Access Compliance Report

Public Rights-of-Way

(Curb Ramps)

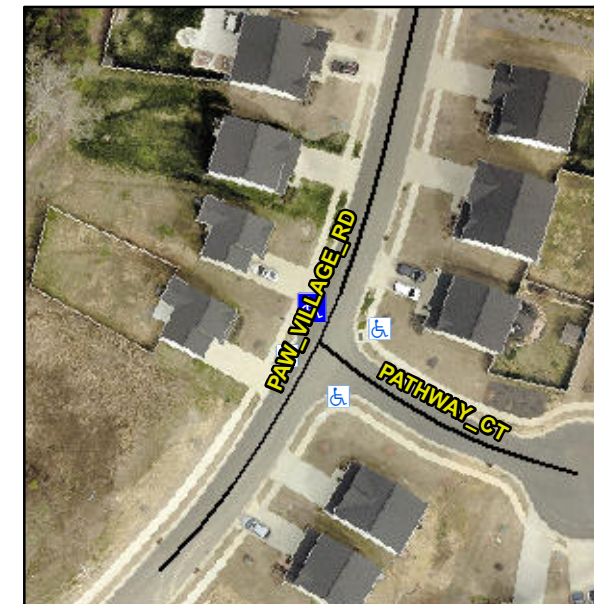
Not Found, R304.5.1, R304.5.3

Compliance	Description	Data	Compliance	Description	Data
N/A	Ramp Length (in)	48.0	Yes	Ramp Slope (%)	6.4
No	Ramp Width (in)	47.5	No	Ramp XSlope (%)	7.0
N/A	Flare Type LT	N/A	N/A	Flare Type RT	N/A
N/A	Flare Slope LT (%)	N/A	N/A	Flare Slope RT (%)	N/A
N/A	Flare Traversable LT?	N/A	N/A	Flare Traversable RT?	N/A
N/A	Landing Length (in)	N/A	N/A	DWS Provided?	N/A
N/A	Landing Width (in)	N/A	N/A	DWS Contrast?	N/A
N/A	Landing Slope (%)	N/A	N/A	DWS Length (in)	N/A
N/A	Landing X Slope (%)	N/A	N/A	DWS Full Width?	N/A
N/A	Landing Curb? (Y/N)	N/A	N/A	DWS Offset (in)	N/A
N/A	Shared Landing?	N/A			
N/A	Gutter Ponding?	N/A	N/A	Gutter Slope (%)	N/A
N/A	Gutter Lip Ht (in)	N/A	N/A	Gutter X Slope (%)	N/A
N/A	Painted X Walk1?	No	N/A	Painted X Walk2?	N/A
	X Walk 1 Direction	To SW		X Walk 2 Direction	N/A
N/A	X Walk 1 Width (in)	N/A	N/A	X Walk 2 Width (in)	N/A
	X Walk 1 Slope (%)	3.8		X Walk 2 Slope (%)	N/A
	X Walk 1 X Slope (%)	10.2		X Walk 2 X Slope (%)	N/A

Remove & Replace Entire Ramp.
